SUBJECT: FORT CALHOUN STATION, UNIT NO. 1 - ISSUANCE OF AMENDMENT  
RE: EXTENDING PRESSURE-TEMPERATURE (P-T) LIMITS (TAC NO.  
MB0322)

Amendment No. 197  
License No. DPR-40

SAFETY EVALUATION BY THE OFFICE OF NUCLEAR REACTOR REGULATION  
RELATED TO AMENDMENT NO. 197 TO FACILITY OPERATING LICENSE NO. DPR-40  
OMAHA PUBLIC POWER DISTRICT  
FORT CALHOUN STATION, UNIT NO. 1  
DOCKET NO. 50-285

Figure 2-1A

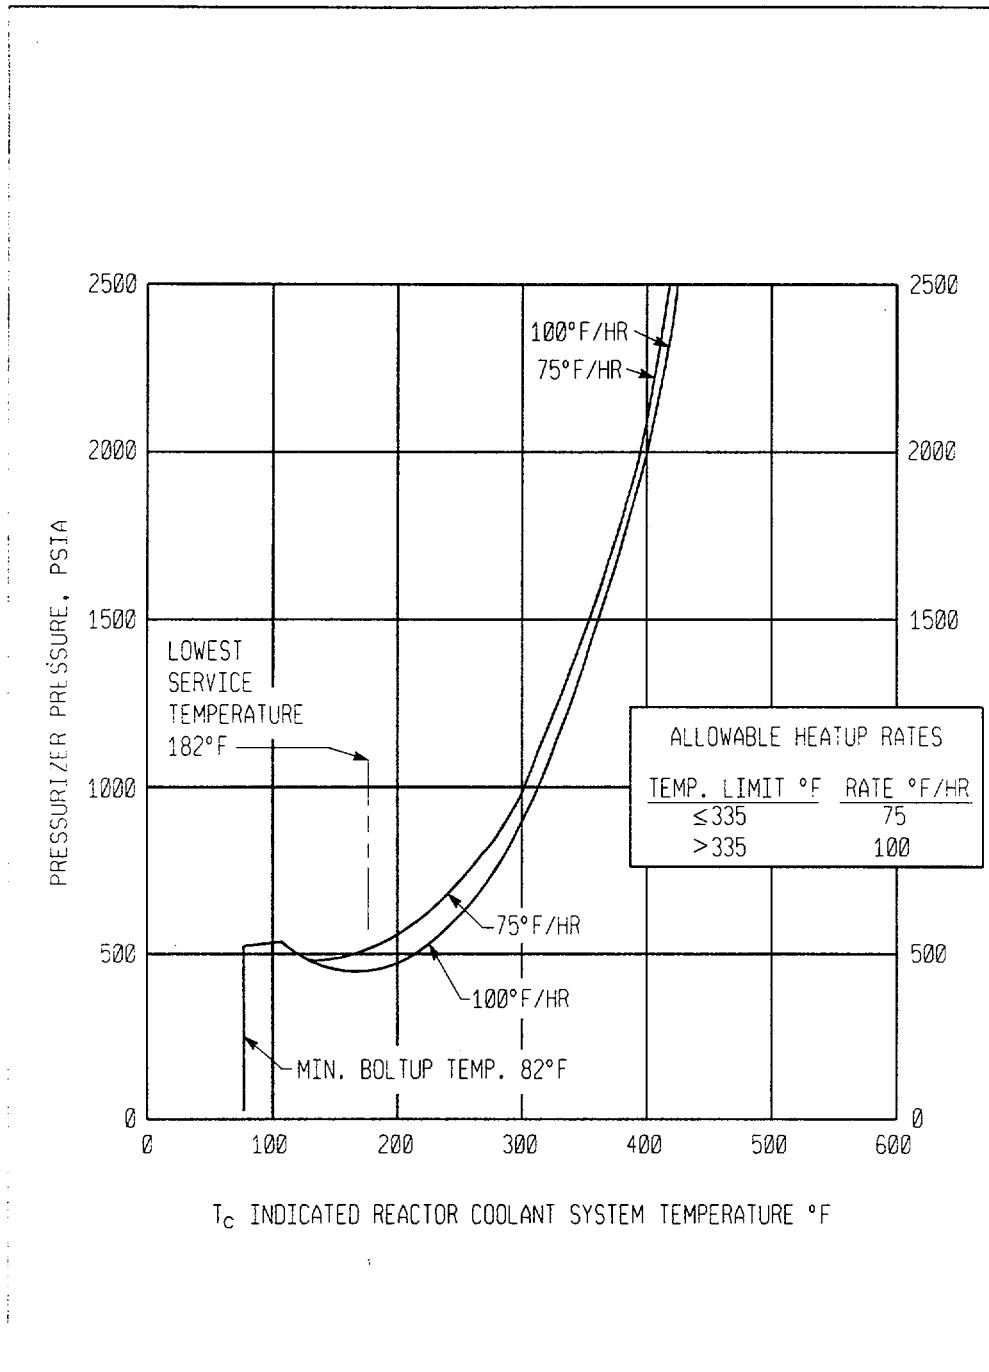
The amendment revises Section 2.1.2, Figures 2-1A and 2-1B, and associated Bases of the Fort Calhoun Station Technical Specifications to extend existing pressure-temperature (P-T) curves from 20 effective full power years (EFPY) to 24.25 EFPY. Additionally, the amendment deletes Figure 2-3, "Predicted Radiation Induced NDTT Shift" and updates the fluence analysis for projecting  $RT_{NDT}$  at 24.25 EFPY.

- In TS 2.1.2, Figures 2-1A and 2-1B, the EFPYs are changed from 20 to 24.25.
- Figure 2-3 in TS 2.1.2 is deleted because the new fuel management scheme renders it obsolete.

- (a) Figures 2-1A and 2-1B are valid for a fast neutron ( $E \geq 1\text{MeV}$ ) fluence of  $1.50 \times 10^{19} \text{ n/cm}^2$  which corresponds to 24.25 EFPY.

FORT CALHOUN STATION UNIT 1 P/T LIMITS, 24.25 EFY
